## Process Sheet

Drawing Name : REWORK

# DART SERVICE INSTRUCTION

TO AMEND INSTALLATION INSTRUCTIONS IIN-D350-636 REV E

**FIGURE 1 - D350-636-011/-012/-013/-014 AT CHG 004 AND INSTALLATION OF DSI 9413-011**  
(LOCATION OF AN526C1032RXX SCREWS ARE NOT TO BE USED TO MOUNT WEARSHOES)

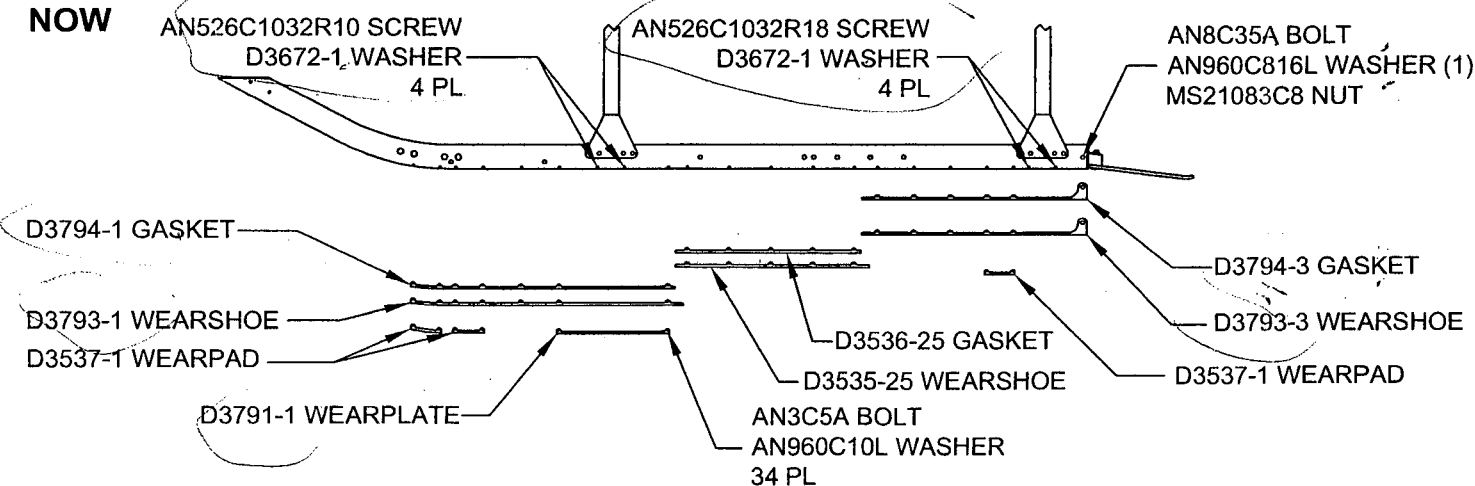
TO IMPROVE THE INSTALLATION OF THE DART D350-636-011/-012/-013/-014 SKIDTUBES ONTO THE CROSSTUBES, THE INSTALLATION AND PART NUMBERS OF THE FWD AND AFT WEARSHOES/GASKETS HAVE BEEN REVISED AS SHOWN IN FIGURE 1 BELOW.

FOR EXISTING CUSTOMERS THAT WOULD LIKE TO IMPROVE THE INSTALLATION OF THE SKIDTUBE TO THE CROSSTUBE, REFER TO PAGE 3 OF THIS DOCUMENT
